Amendments to the Figures:

Remarks:

In response to the Office action mailed November 1, 2004, Applicant respectfully requests reconsideration, reexamination and allowance of claims 1-2 and 5-10 in view of the above amendments and the following remarks.

Fig. 4

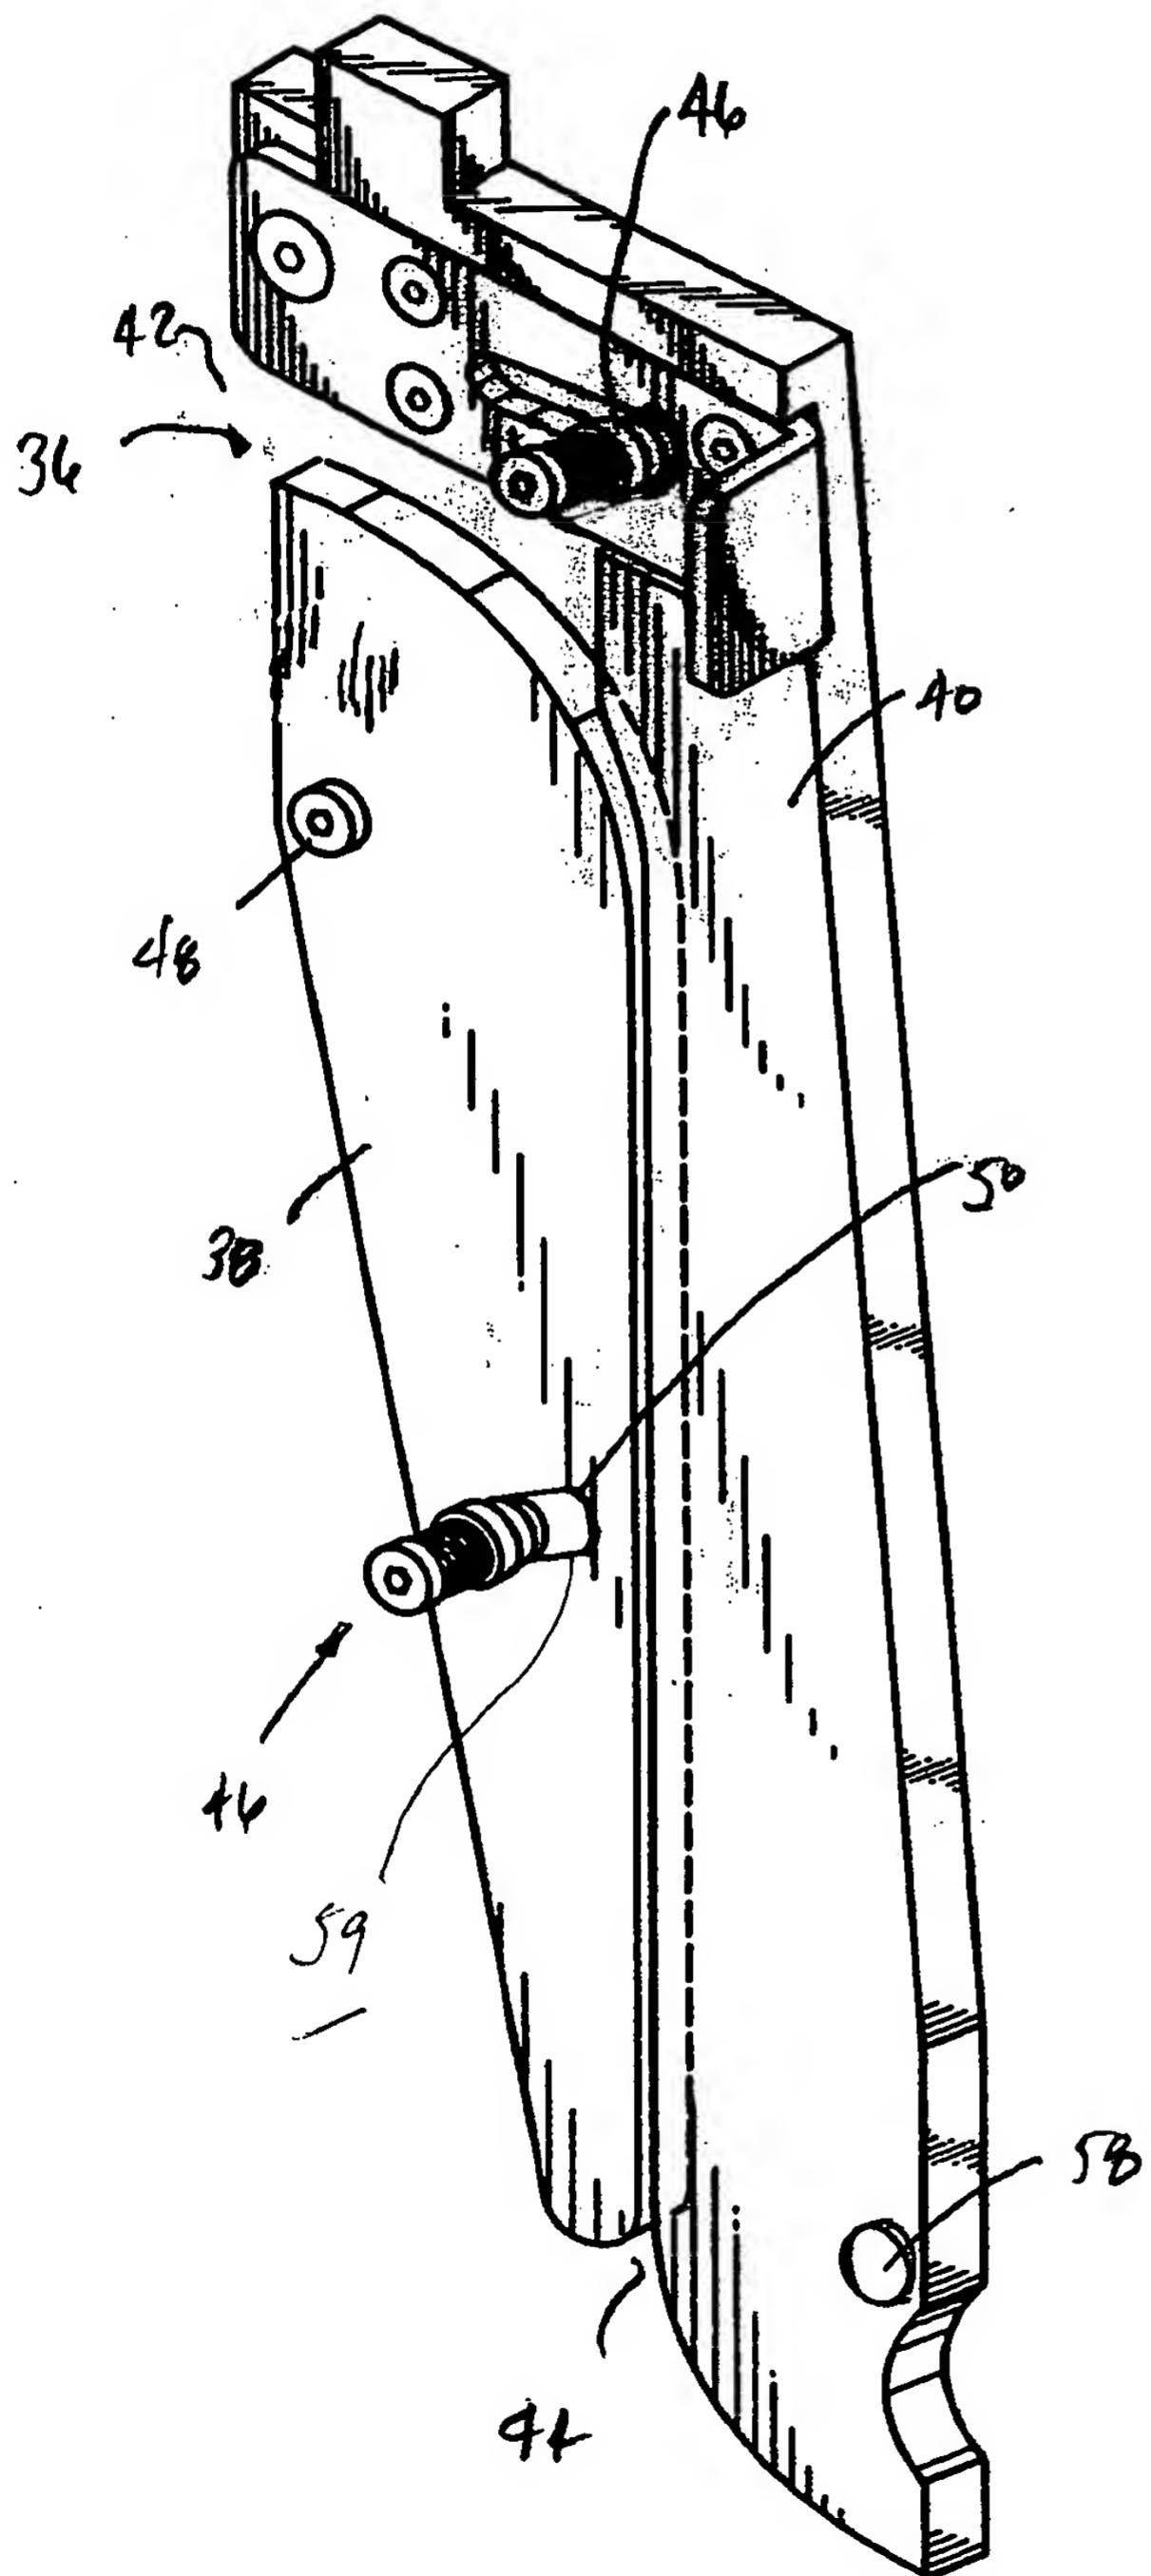
The Examiner has also objected to the use of reference character 58 to indicate both the enlarged portion and the pivot pin. Applicant has, as noted above, amended the specification to

Amendments to the figures are shown on the appended sheet 4 of 21 (FIGS. 4 and 5) and sheet 16 of 21 (FIG. 23). In FIGS. 4 and 5, reference numeral 59 has been added and in FIG. 23 reference numeral 114 has been added. These sheets are annotated as replacements sheets. Applicant respectfully requests entry of these replacement sheets in the application file.

change enlarged portion to reference number 59 and has amended FIGS. 4 and 5 accordingly. Applicant respectfully submits that this objection has now been fully addressed and that it be withdrawn.

Fig. 23

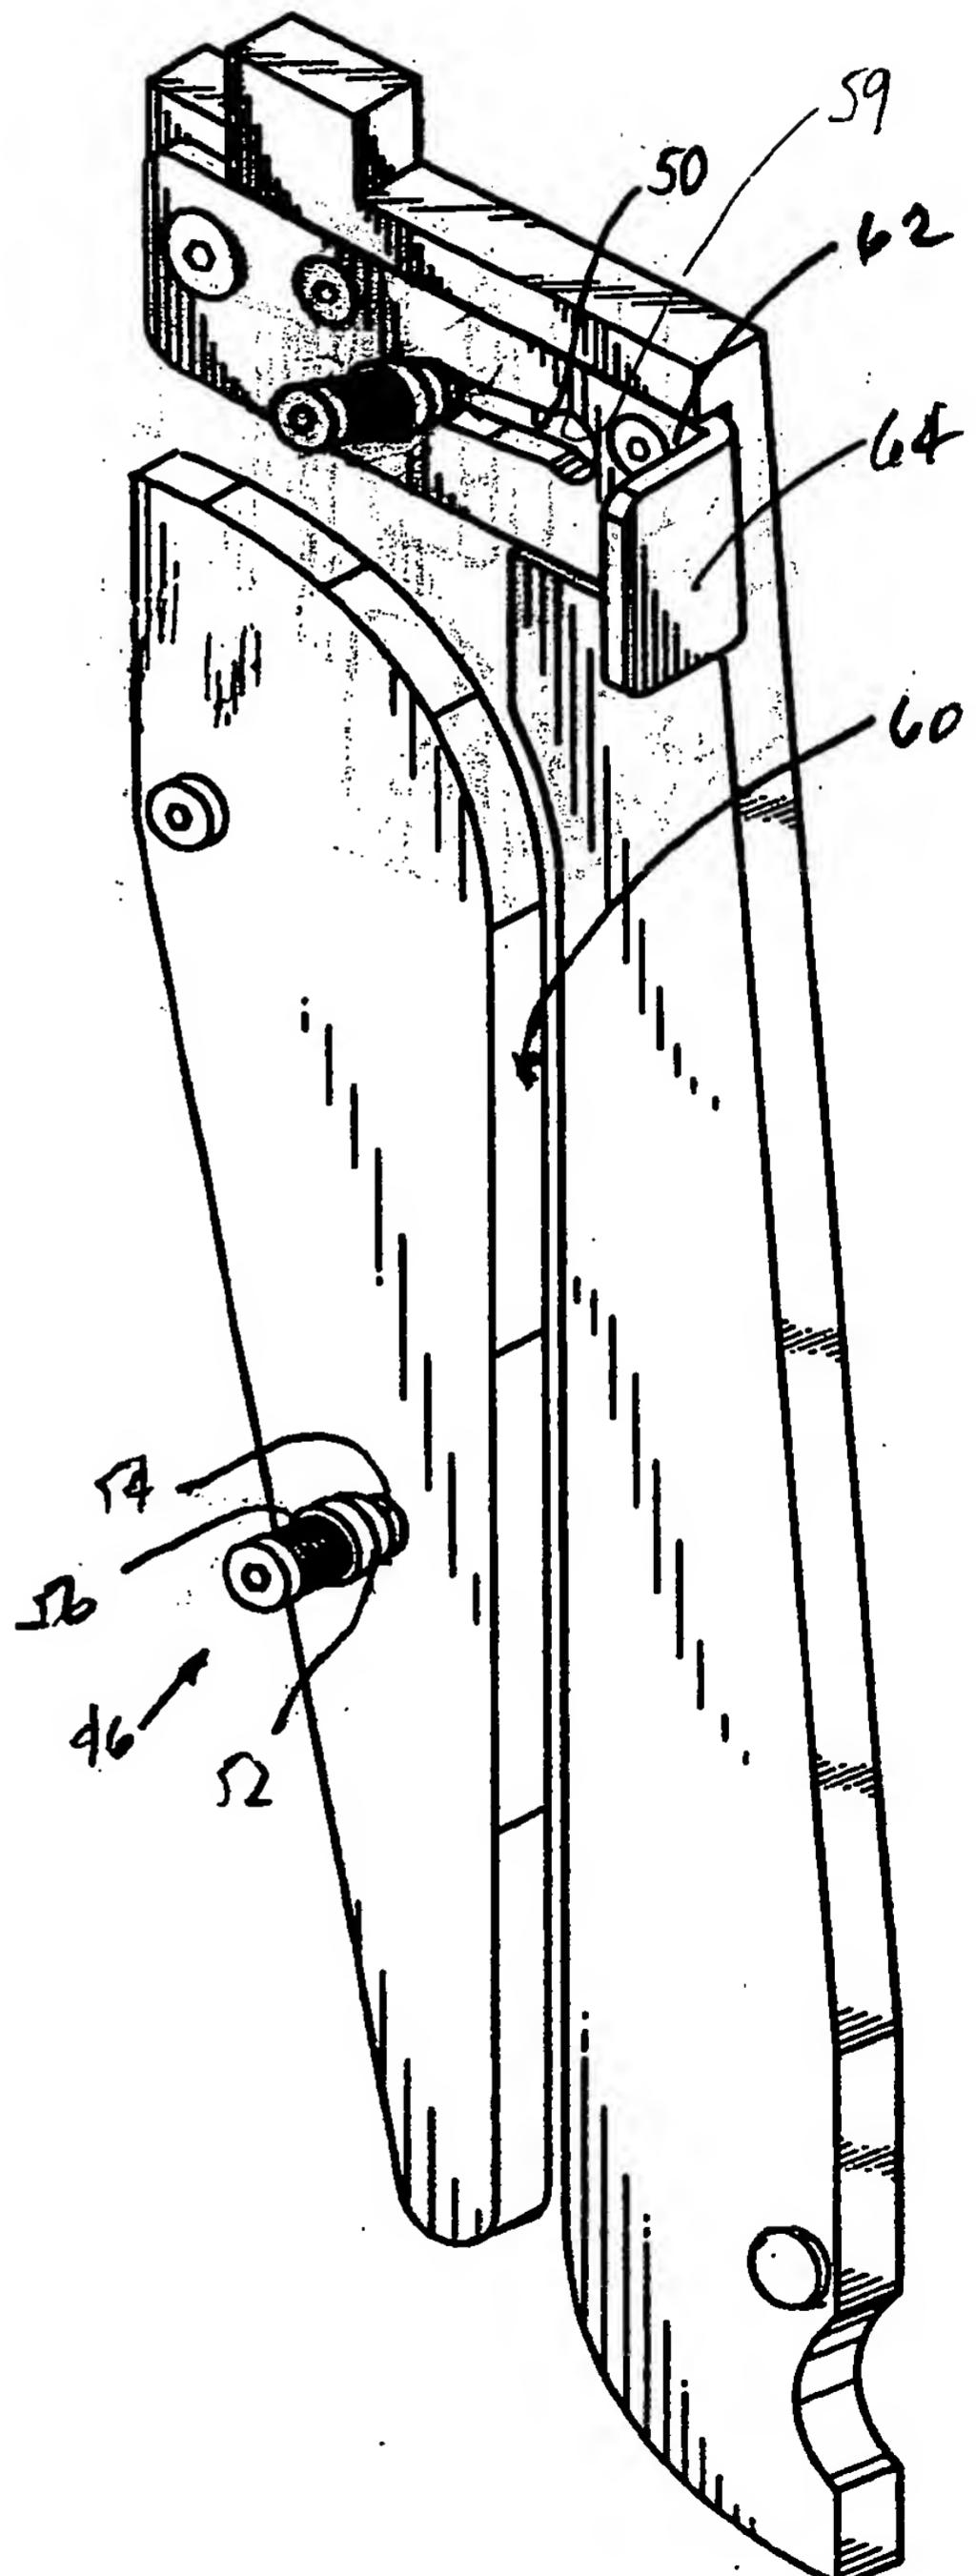
The Examiner has first objected to the drawings on a number of grounds. First, the Examiner notes that reference numerals 114 and 154 are mentioned in the specification but not shown in the drawings.

Applicant has amended FIG. 23 to include numeral 114 and directs the Examiner's attention to FIG. 8 which shows spring 154. Applicant respectfully requests that the Examiner withdraw these objections.
